**CITY OF LOUISVILLE
STARK COUNTY, OHIO**

METZGER PARK BASEBALL & SOFTBALL FIELDS

ADDENDUM #4

September 25, 2023

GENERAL NOTES

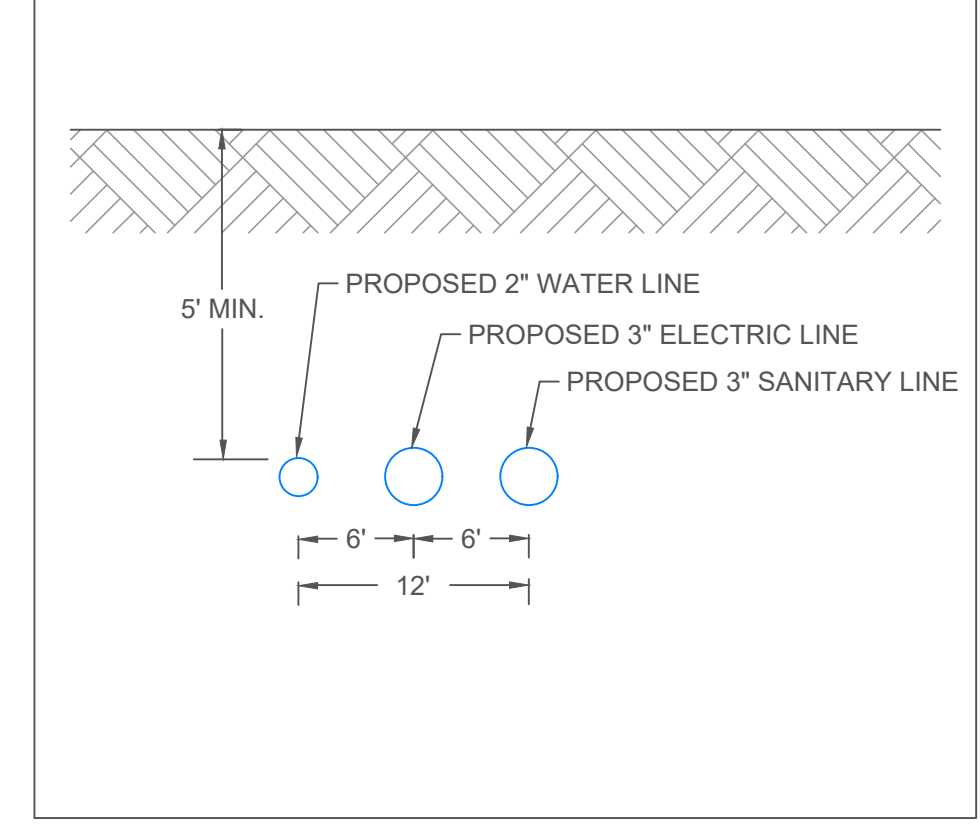
8. Will we be responsible for the cost and physical relocation of any existing utilities which don't meet the required minimum depths called out in the specifications for this project?

Please review Note 26 on Sheet 2. Also, the existing utility quantity has been added to the Bid Form.

UTILITY PLAN-1

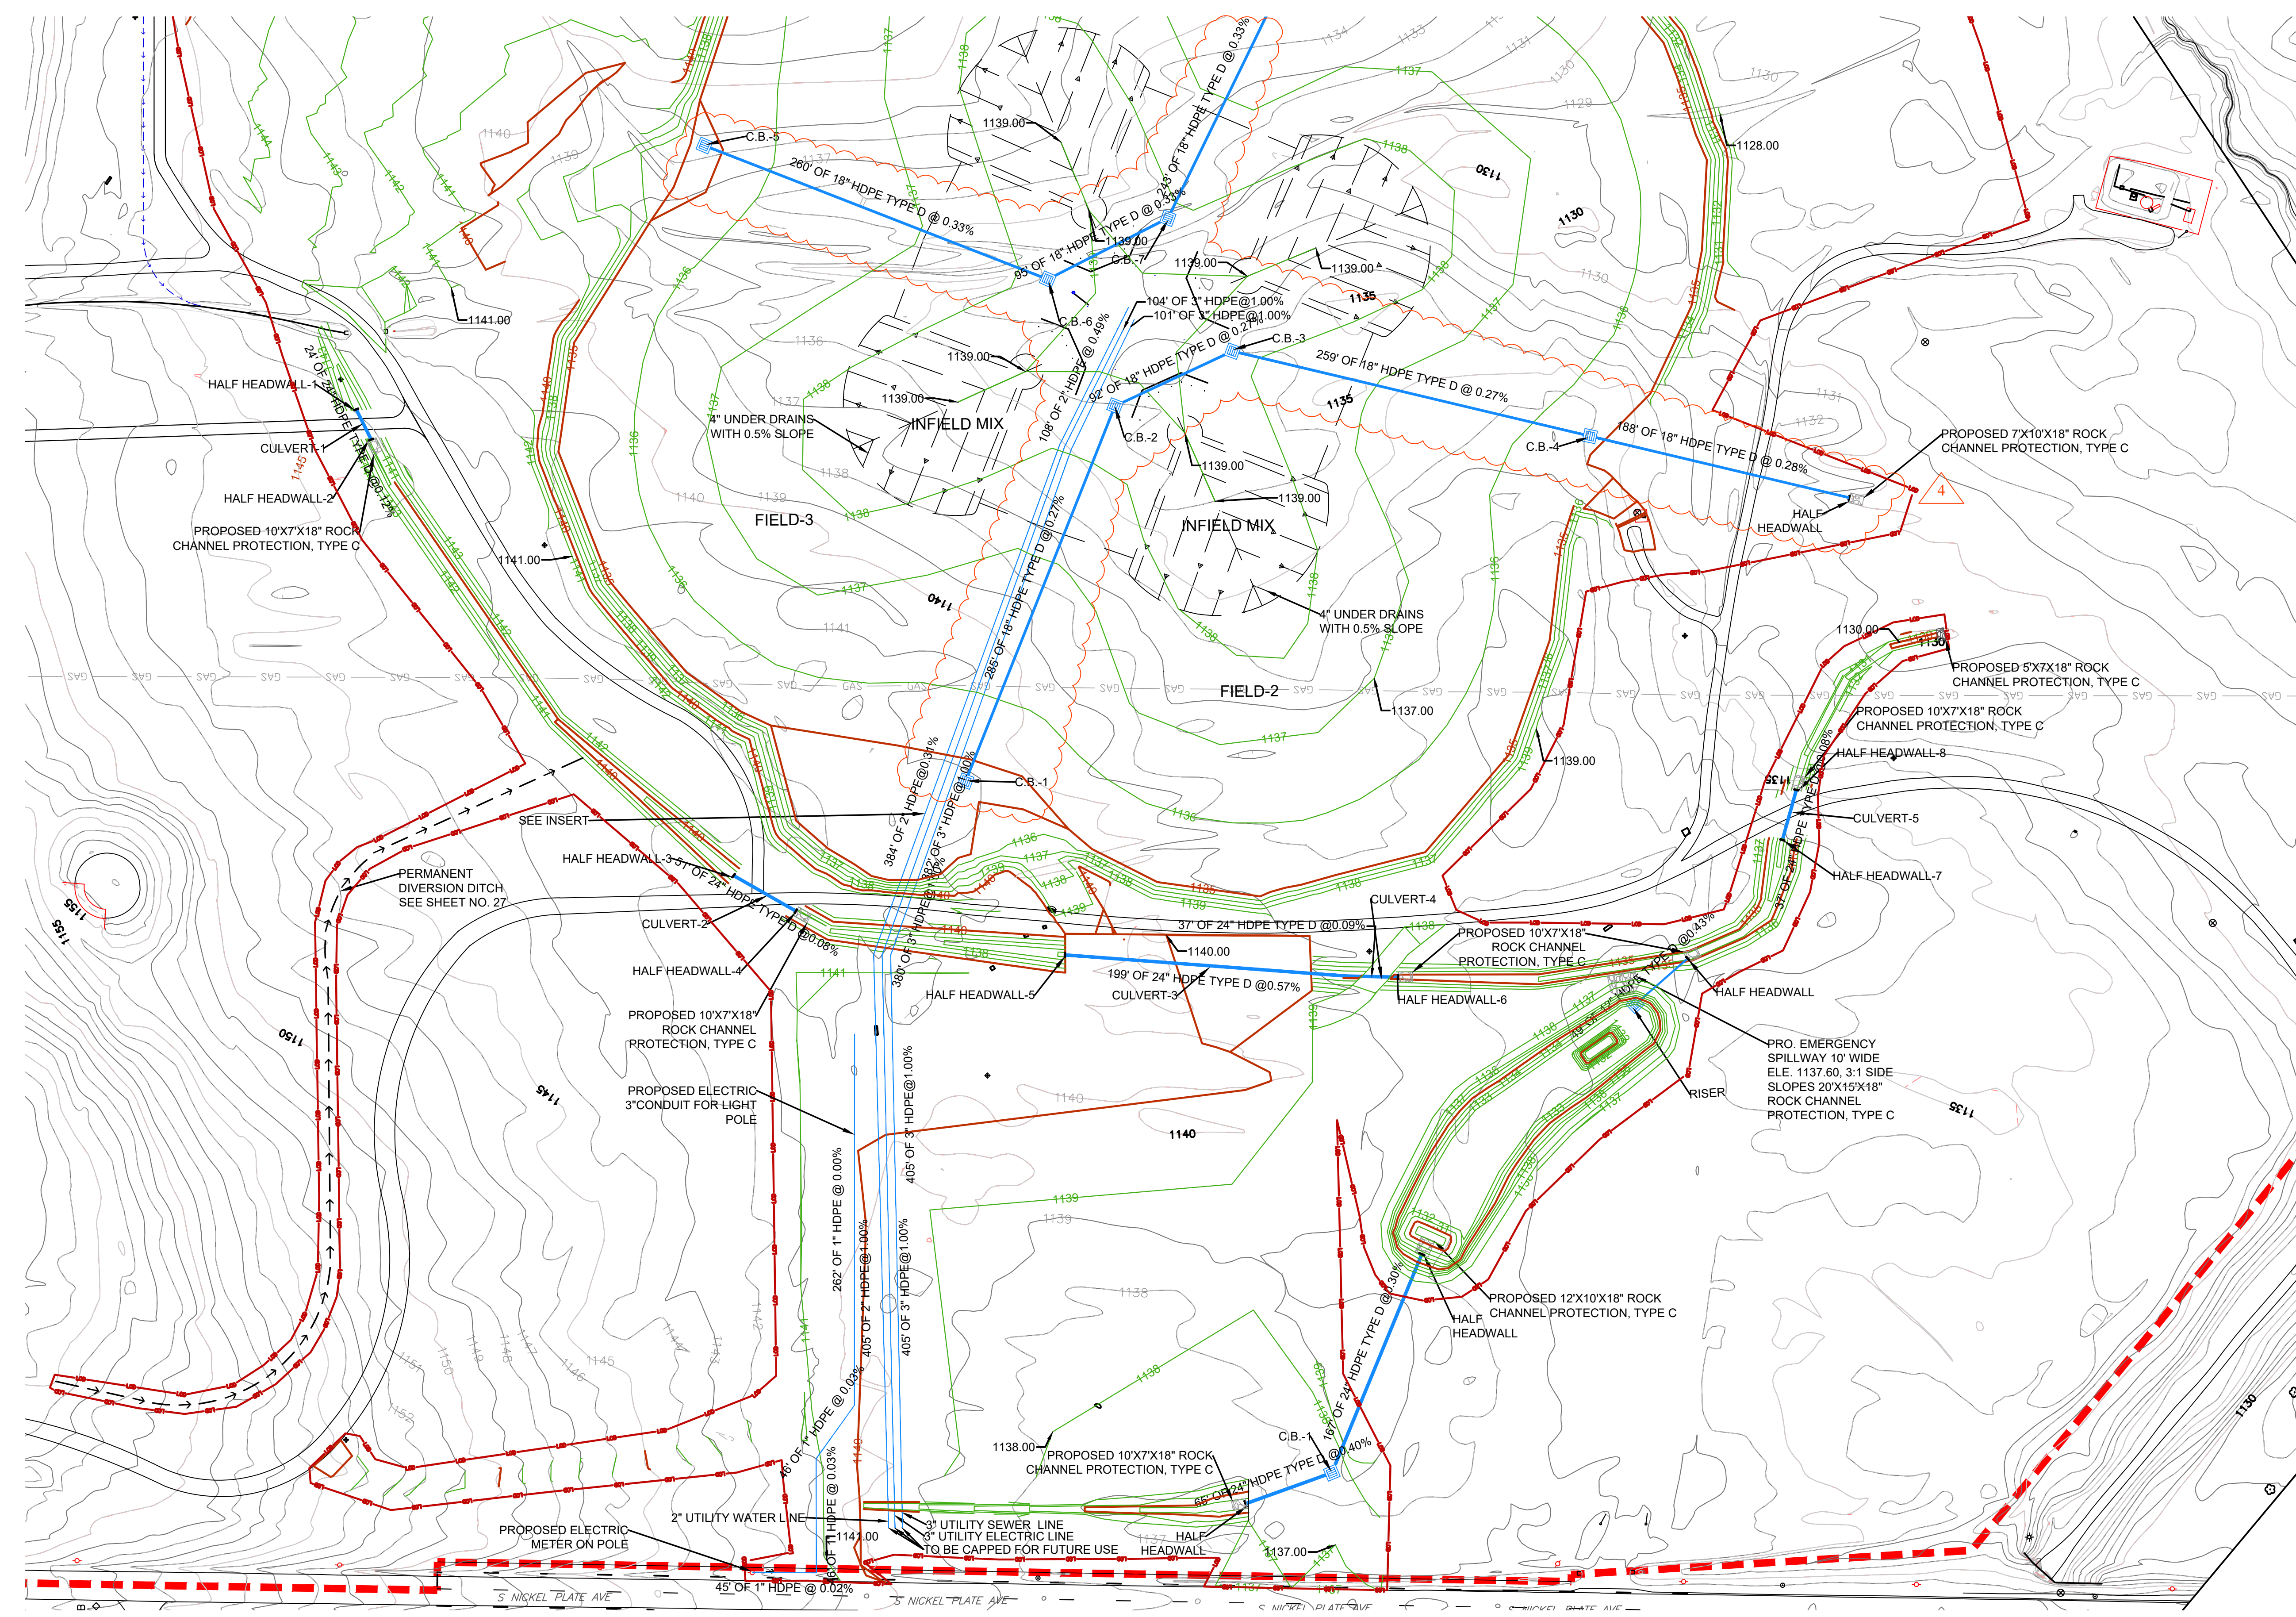
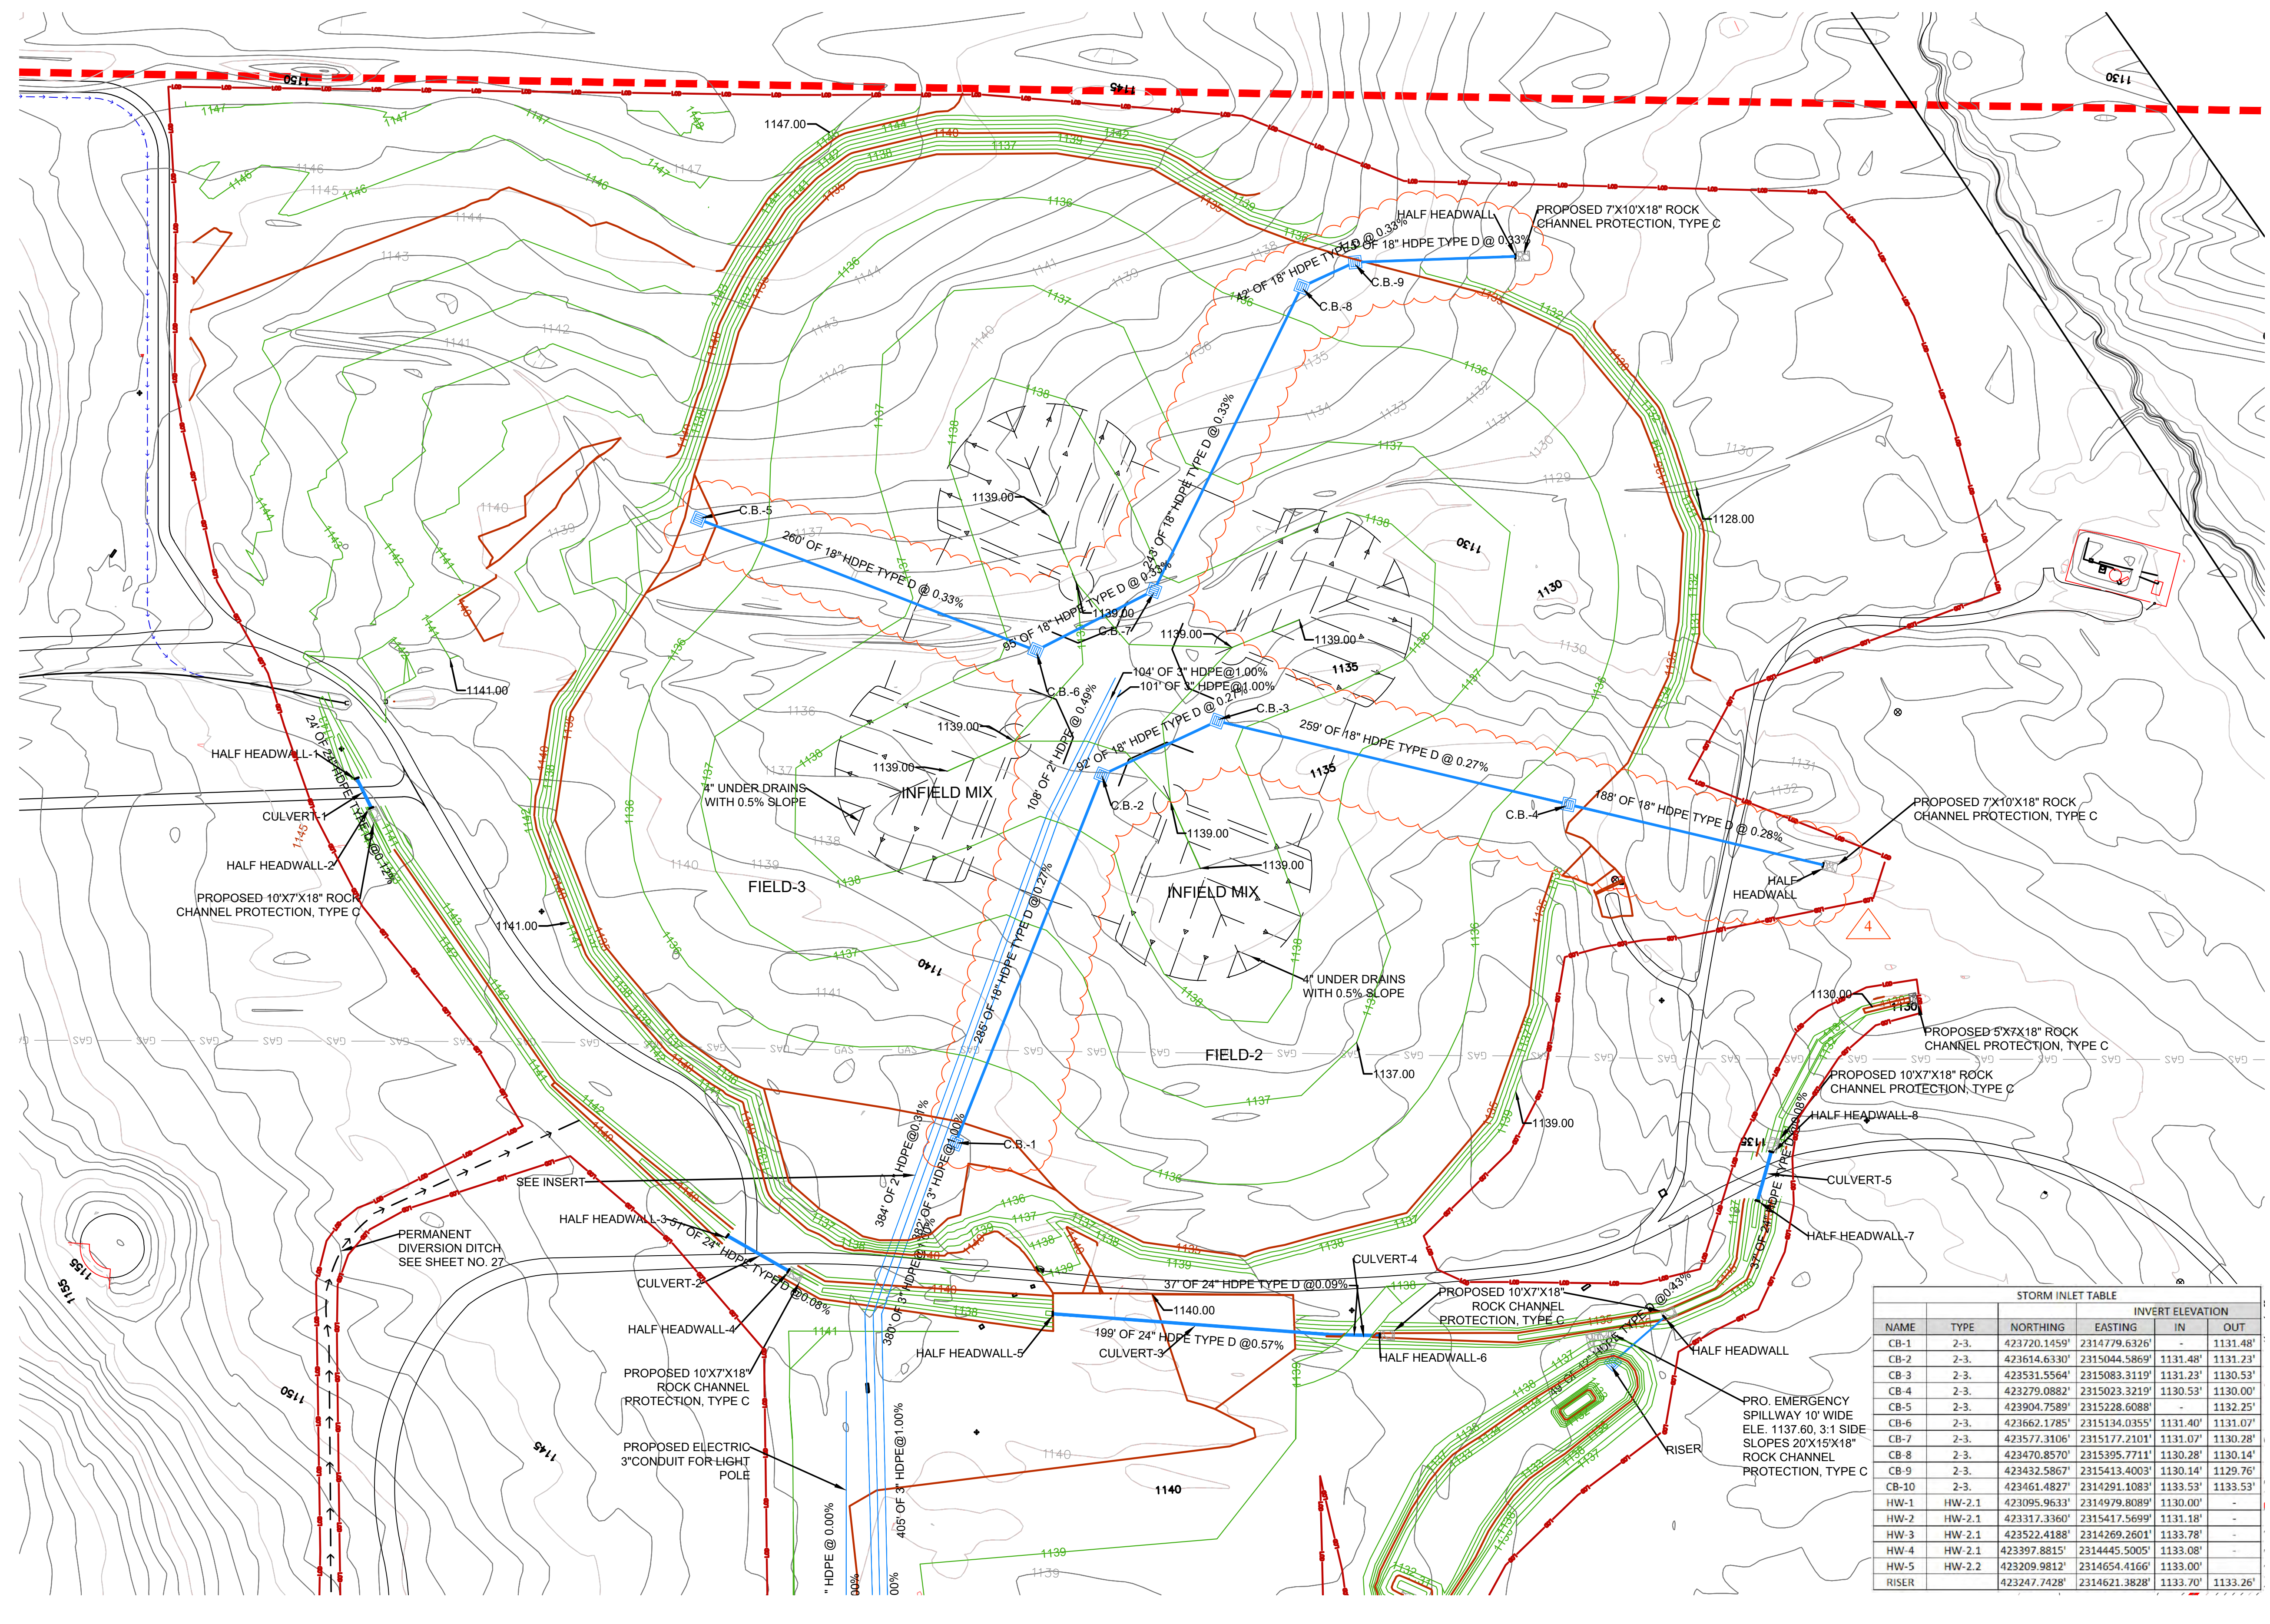
17. On Sheet 10, a reference is made to a proposed alternate utility conduit. Please clarify that you want the electrical conduit between the water line and sanitary sewer.

Yes, the electrical conduit will be installed between the water line and sanitary sewer.
